Re: **Dunmore Landfill Waste Licence No. W0030-02, Condition 1.2 – Request for Technical Amendment**

**WASTE LICENCE BOUNDARY AMENDMENT
DUNMORE LANDFILL, COUNTY KILKENNY
WASTE LICENCE REF. NO. W0030-02
ORIGINAL
KILKENNY COUNTY COUNCIL**

Abstract: This document describes the proposed amendment to the waste licence 'red line' boundary at Dunmore Landfill, Kilkenny.

Figure 2.1: Typical deep slope failure for Slope A-A with groundwater level 1.5 m above liner, 52mOD (fresh waste, Morgenstern-Price method)

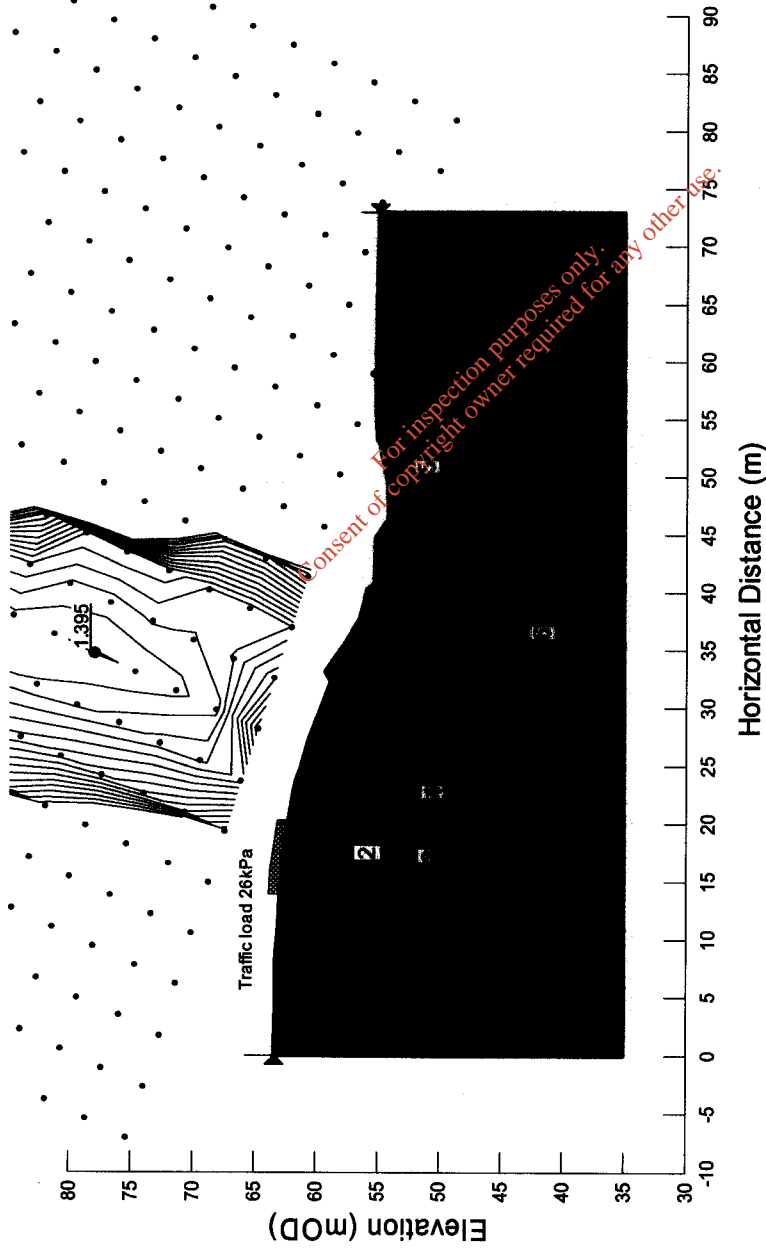
The factor of safety for slope A-A ranges from 1.03 to 1.39. This slope can therefore be considered stable provided that leachate levels are monitored and maintained.

Figure 2.2: Typical deep slope failure for Slope B-B with groundwater level 1.5 m above liner, 52mOD (old waste, Morgenstern-Price method)

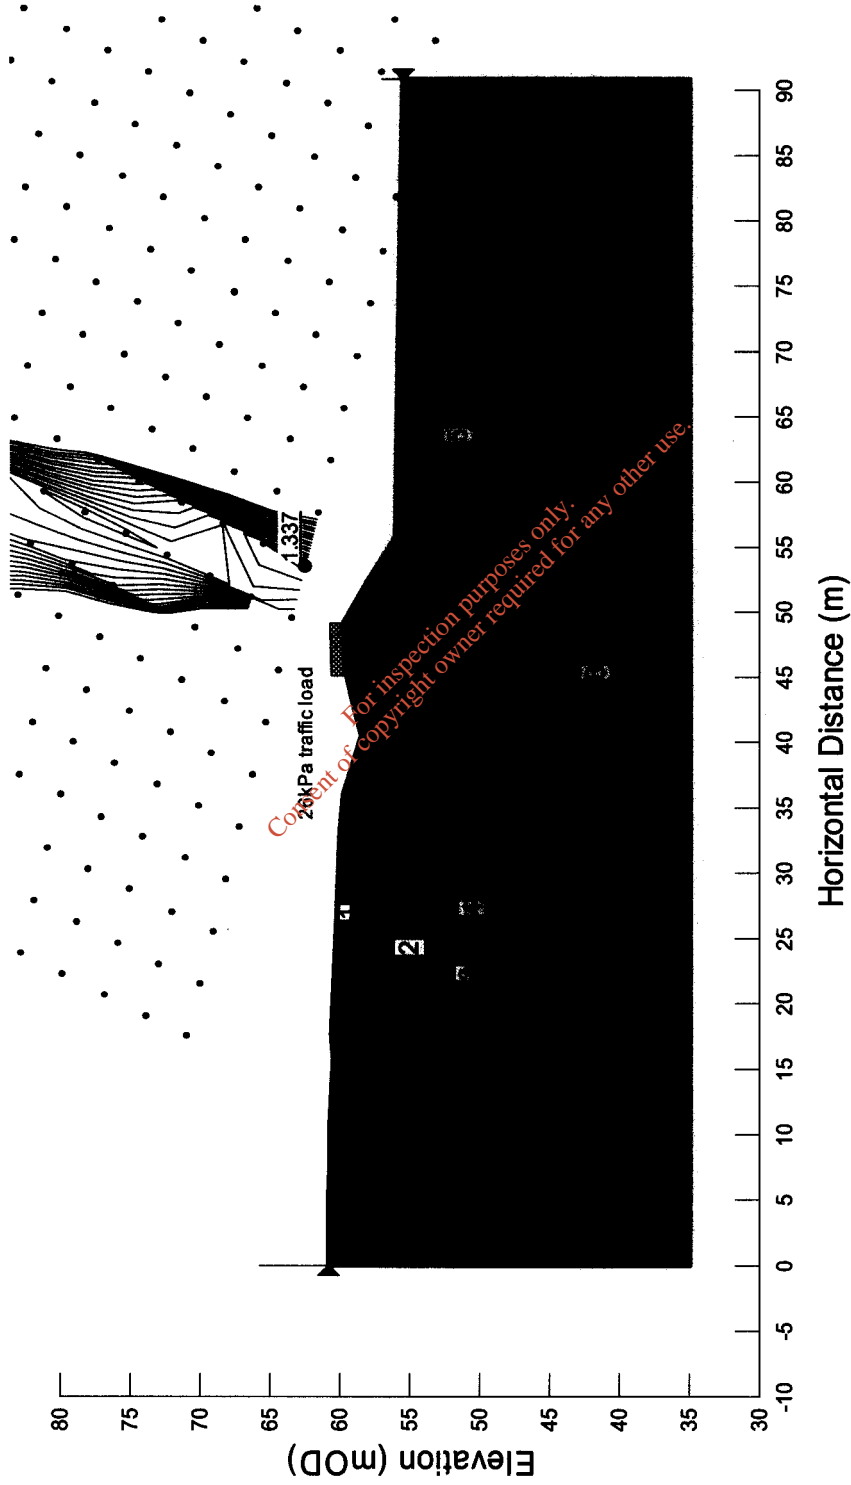
The factor of safety for slope B-B ranges from 1.14 to 1.34. This slope can therefore be considered stable provided that leachate levels are monitored and maintained.

Figure 2.3: Typical deep slope failure for Slope C-C with groundwater level 1.5 m above liner, 52mOD (old waste, Morgenstern-Price method)

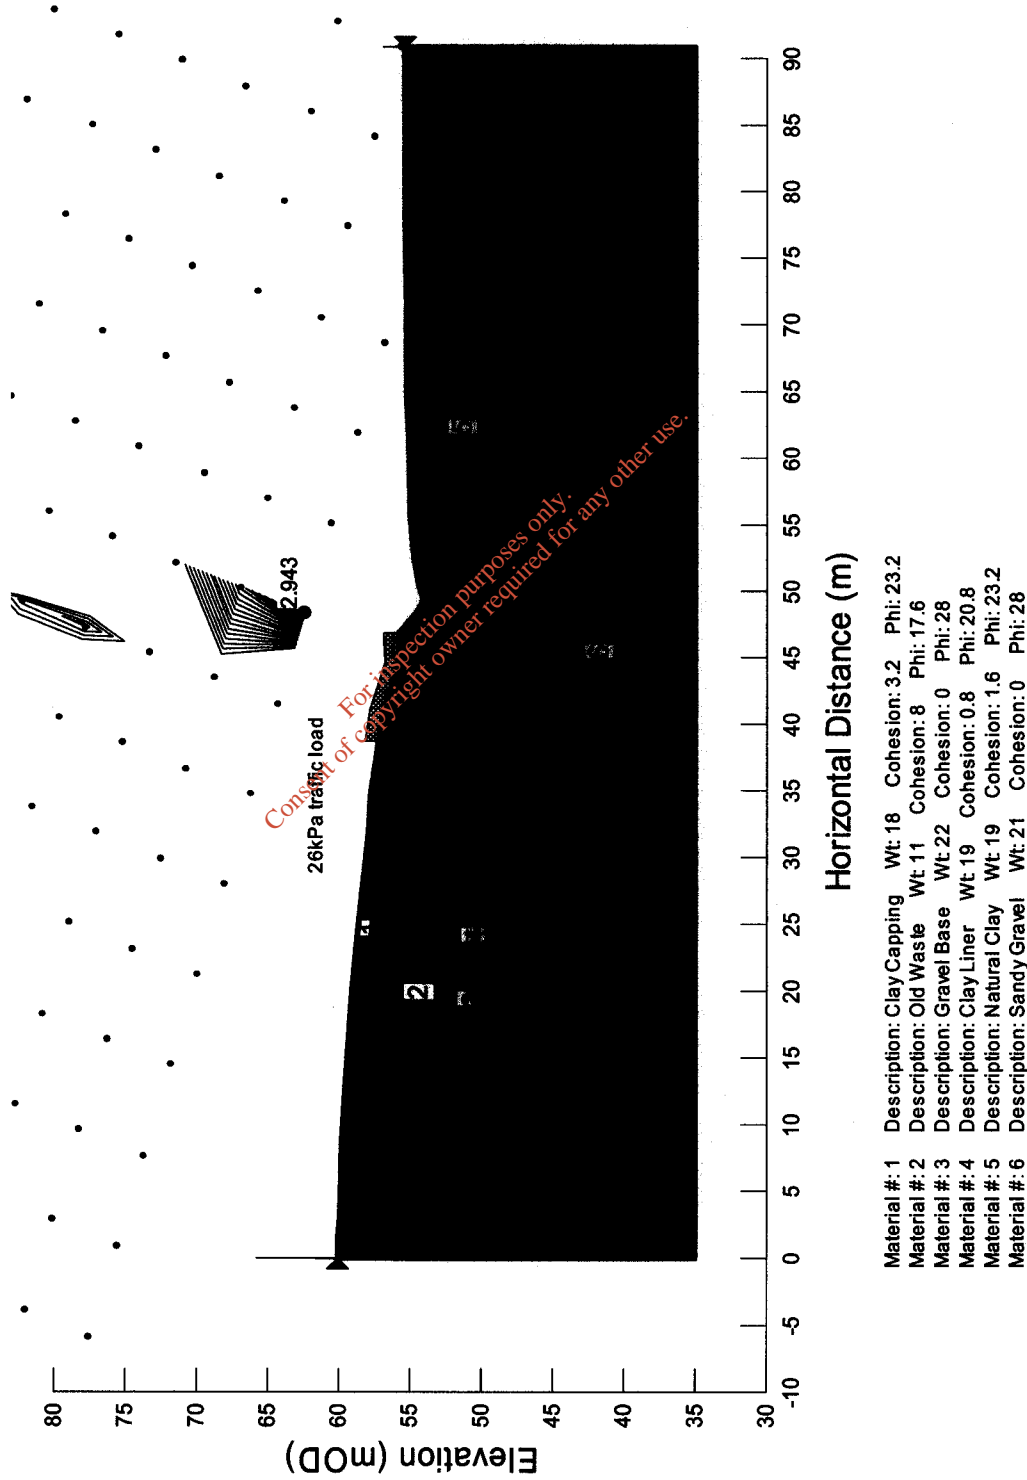
The factor of safety for slope C-C ranges from 1.14 to 2.85. This slope can therefore be considered stable provided that leachate levels are monitored and maintained.
